Action ID: SAW-2005-21386

Subject: Modification to the 401 Water Quality Certification Pursuant to Section 401 of the Federal Clean Water Act for proposed Greensboro Eastern Loop from US 70 Relocation to SR 2303 (Lawndale Drive), Guilford County, Division 7. WBS Element No 34821.1.1, TIP Nos. U-2525B and U-2525C. NCDWR Project No. 20130918 ver.6.

**PERMIT DRAWING
SHEET 32 OF 93**

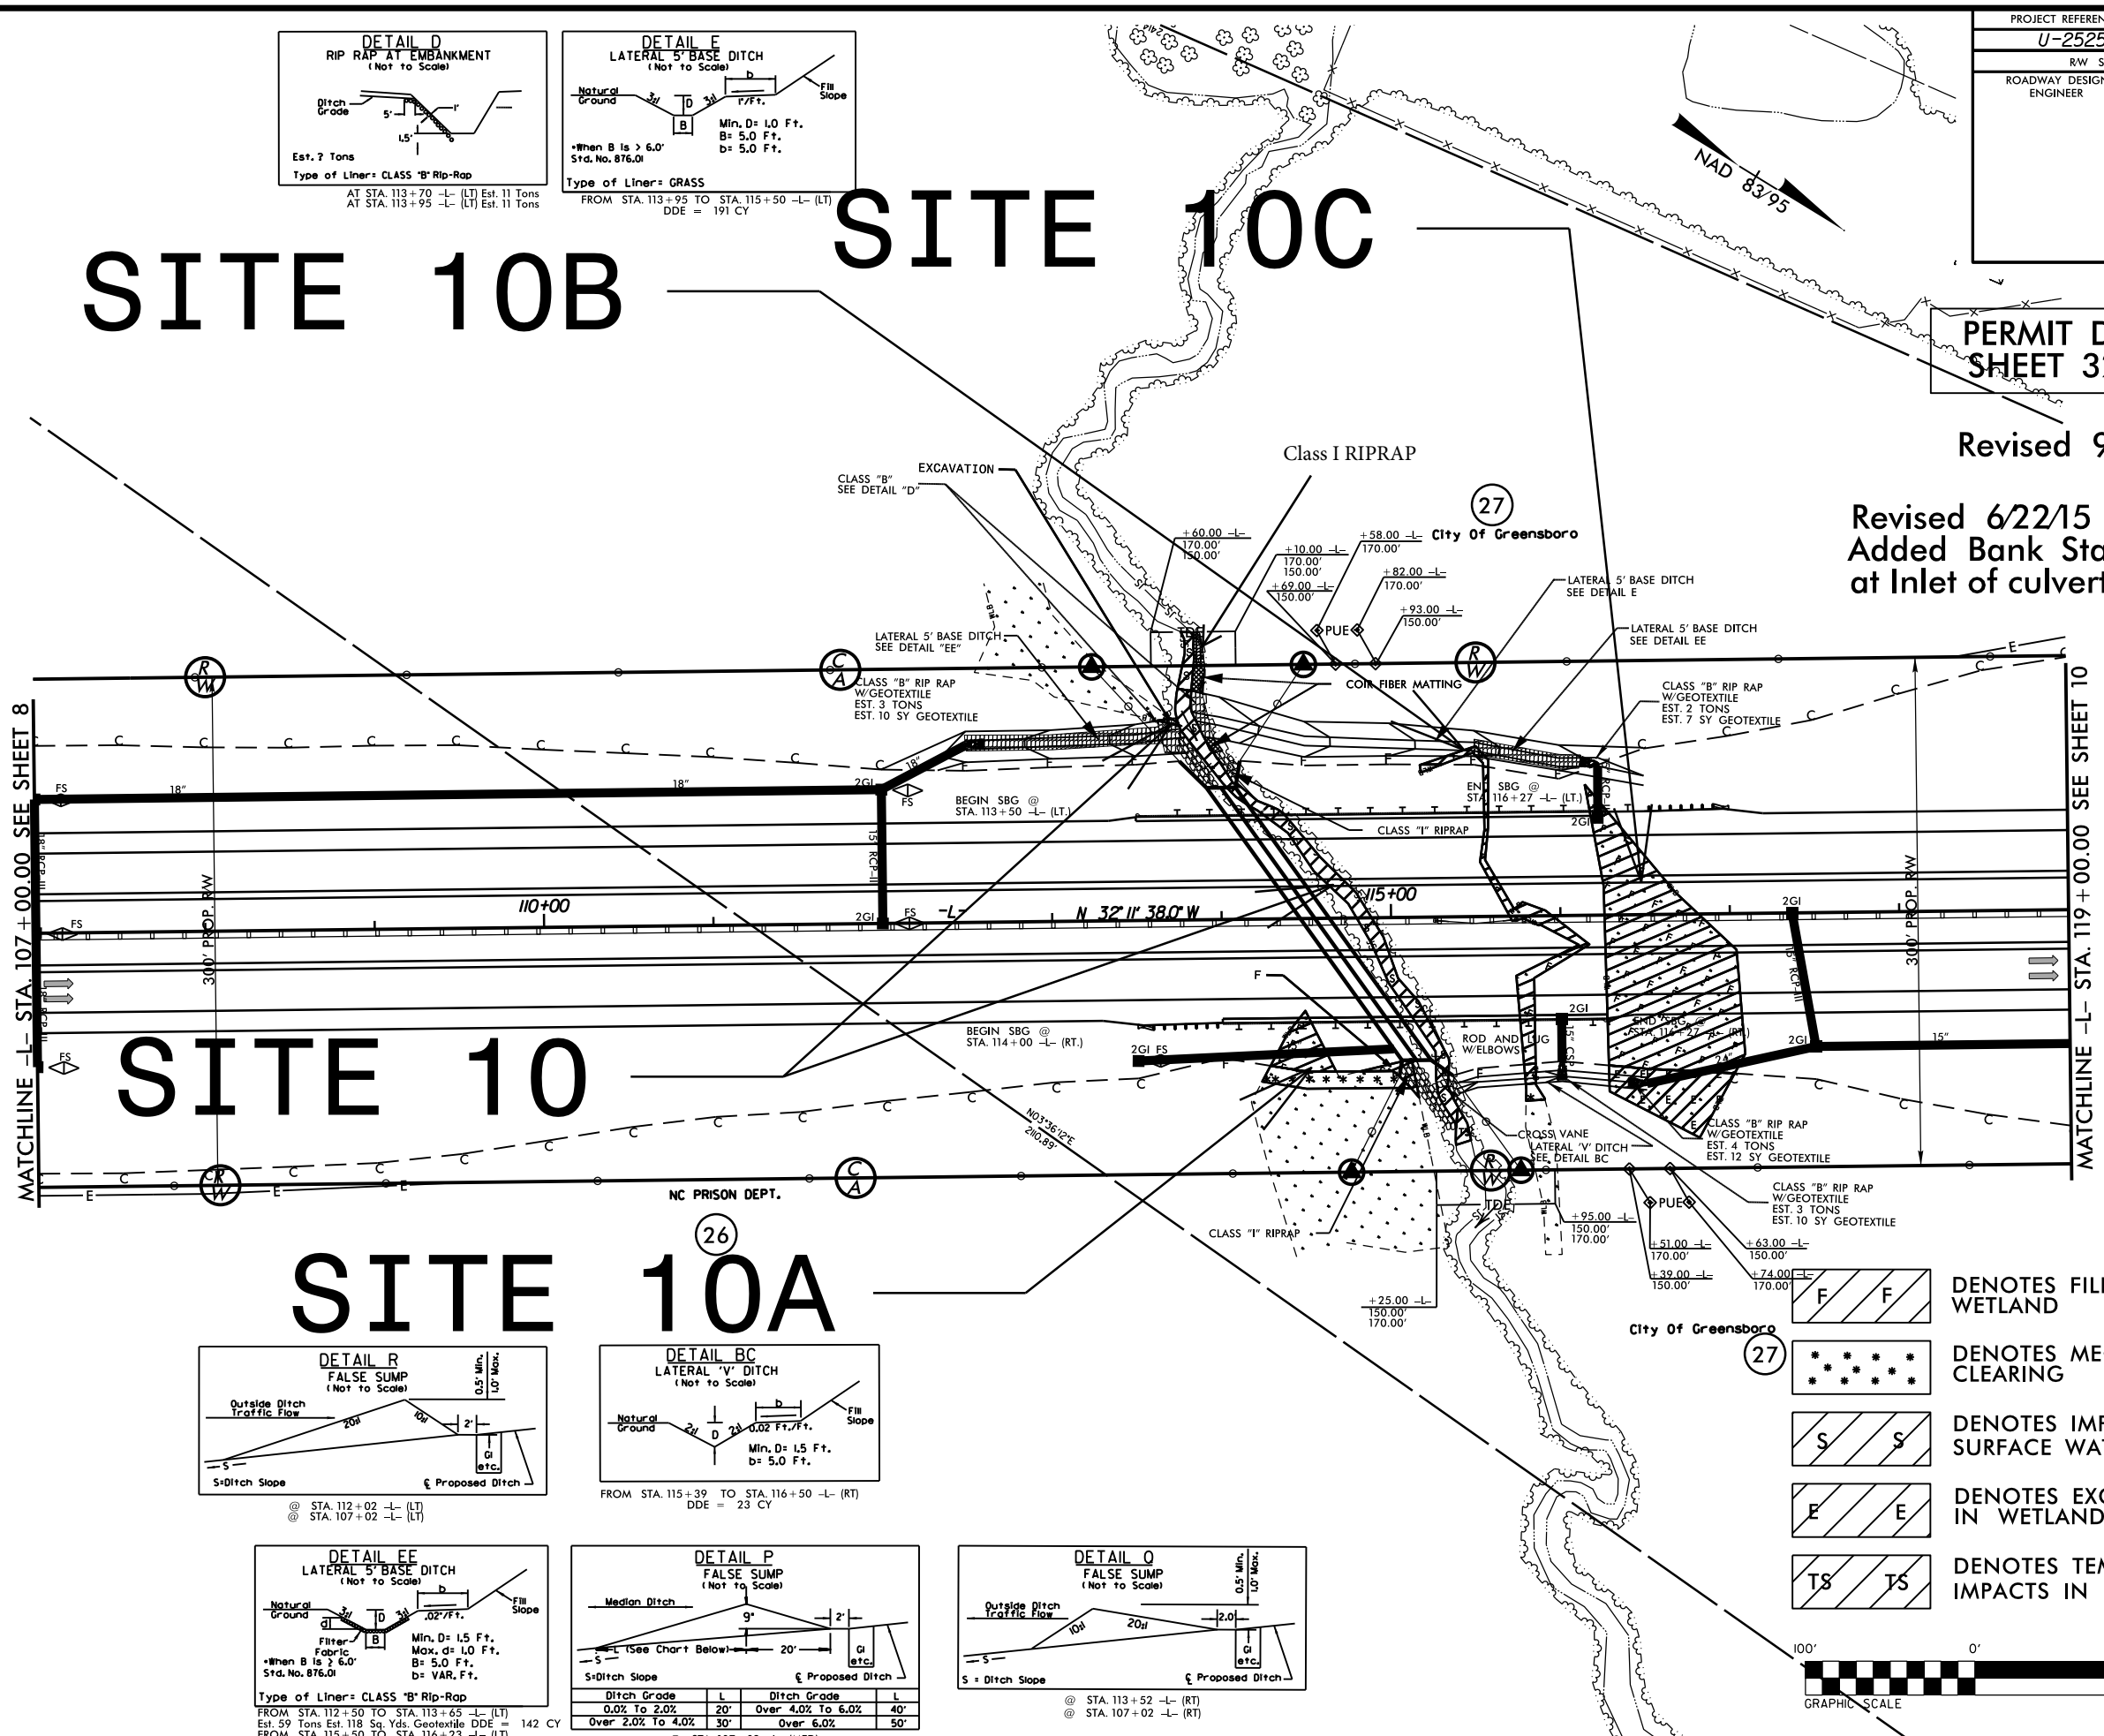
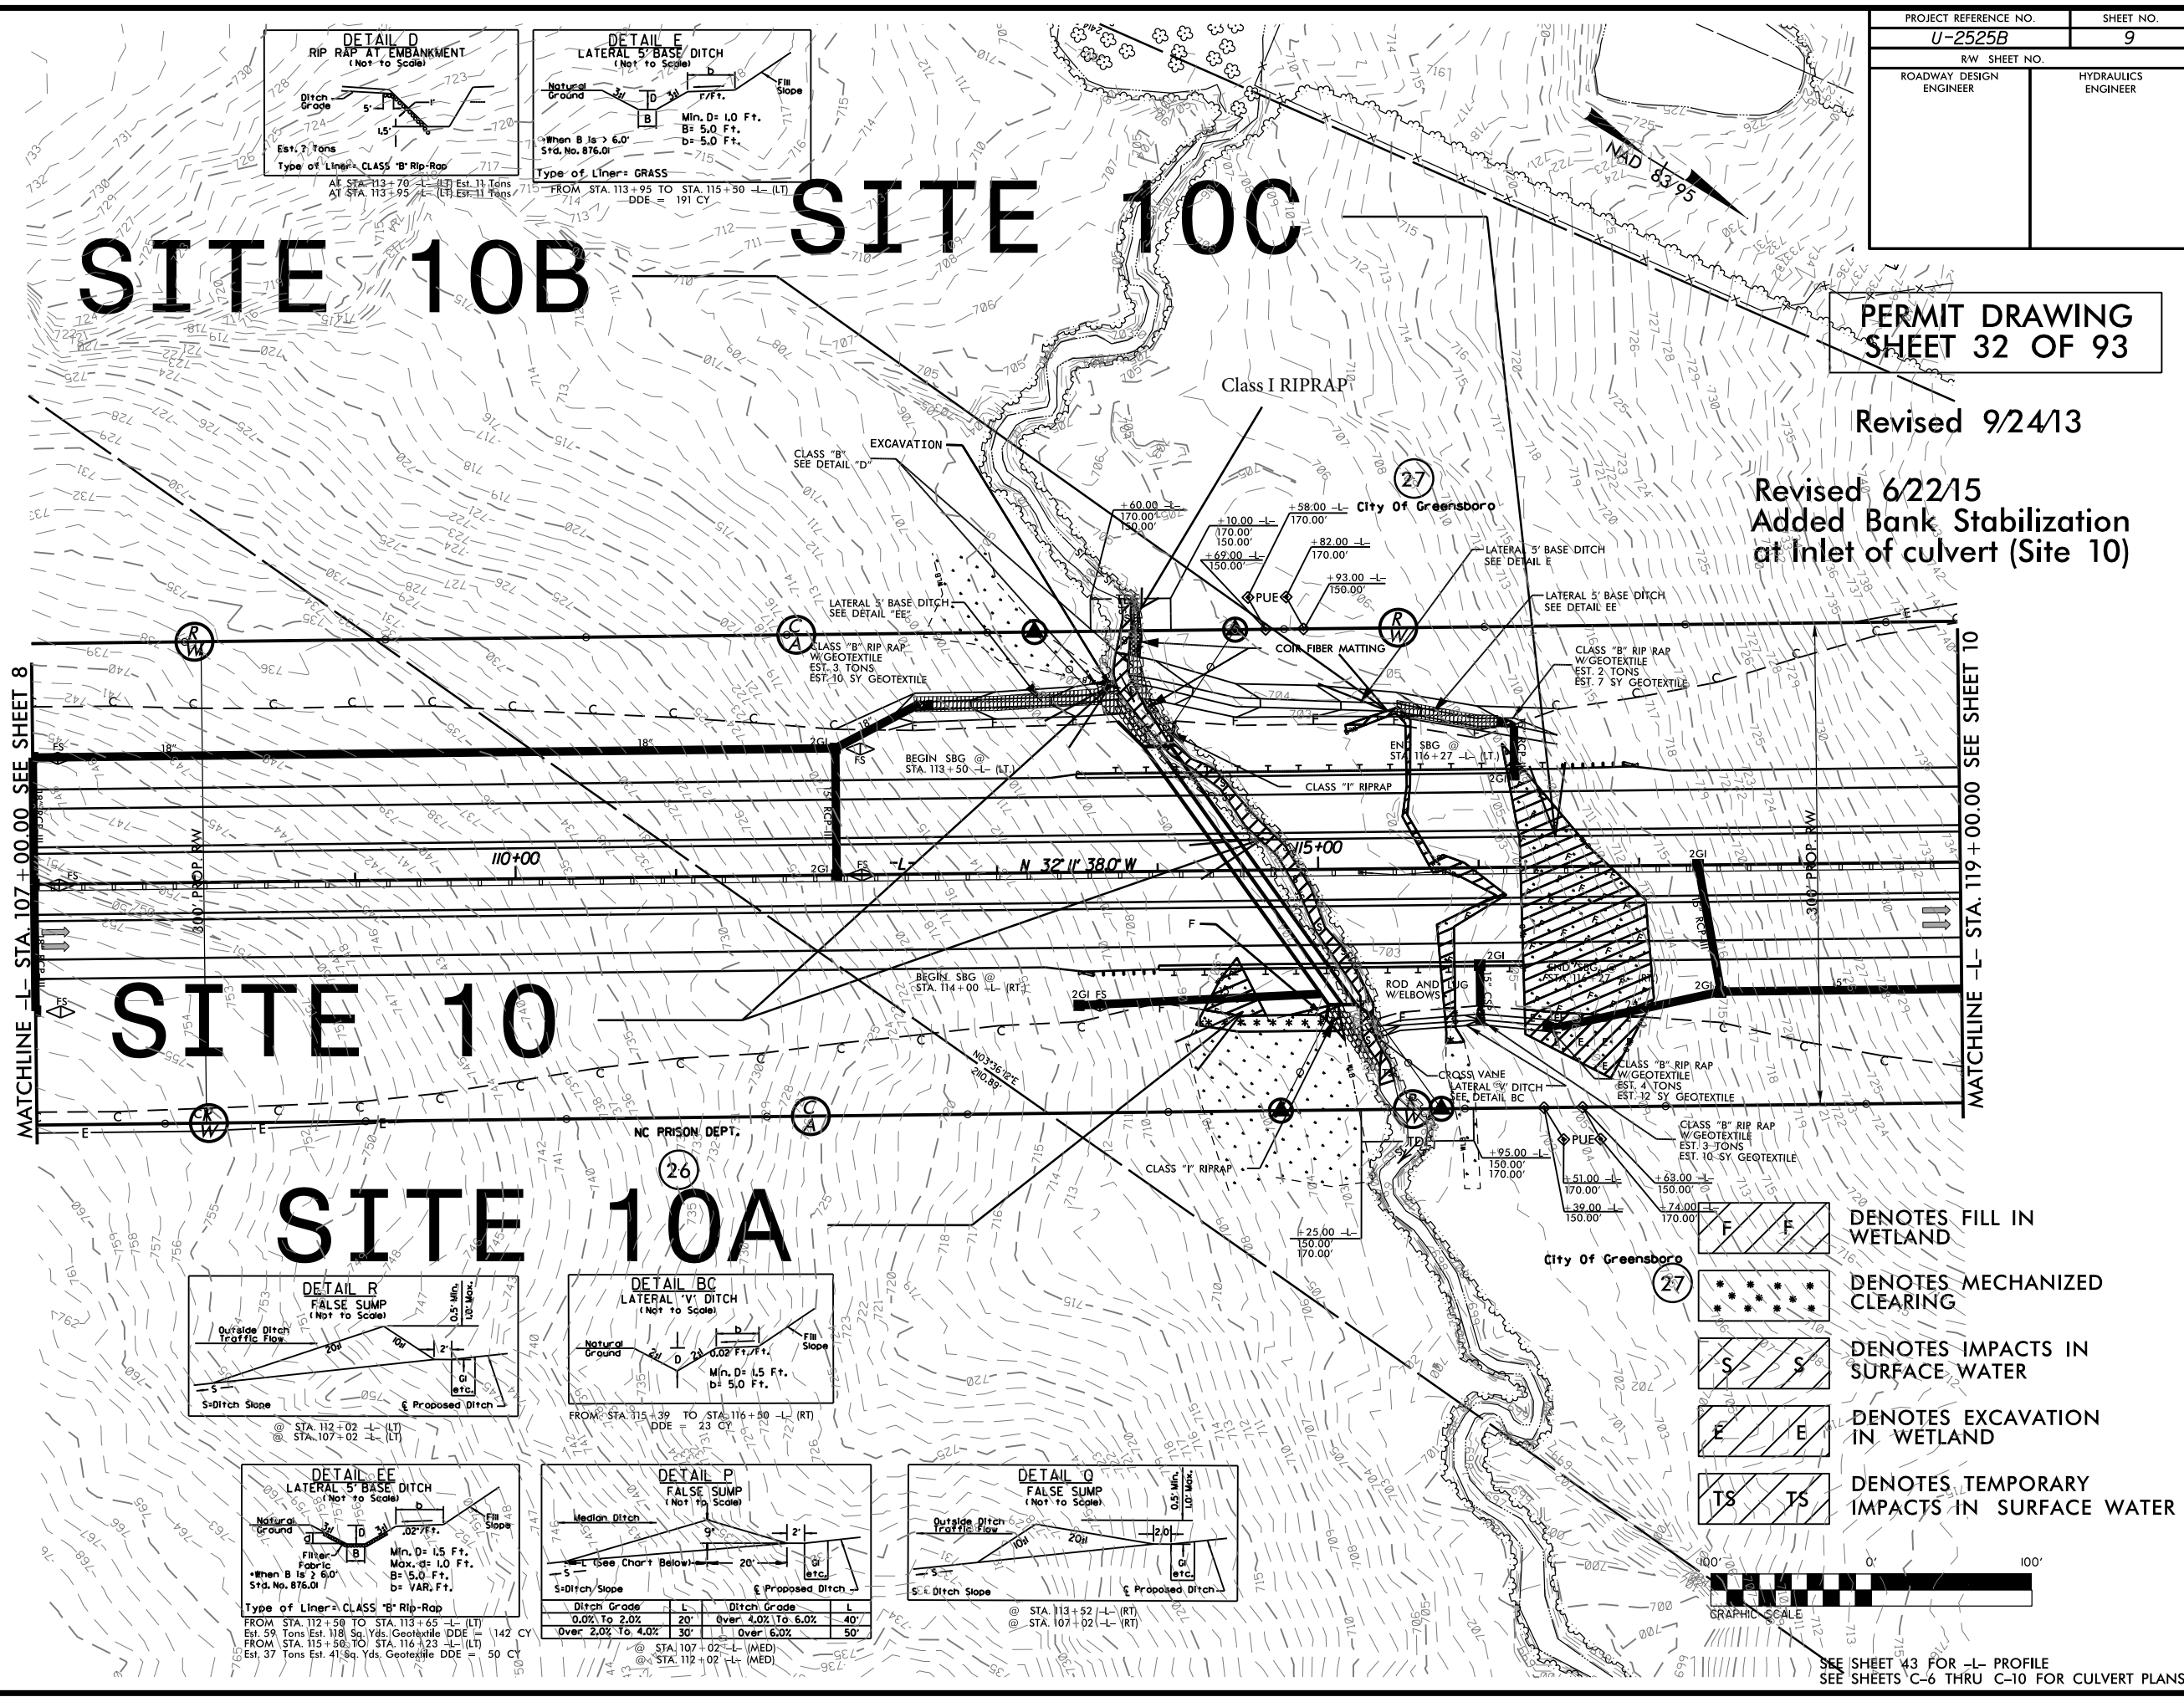
- 3) adding 35 linear feet of additional bank stabilization to a stream at Permit Site 10 (replacing 14 linear feet of temporary impacts authorized in the original permit), including 9 linear feet of rip rap and 26 linear feet of coir fiber matting, to account for predicted stream bank instability following closure of a temporary diversion channel; and

Revised 6/22/15
Added Bank Stabilization
at Inlet of culvert (Site 10)
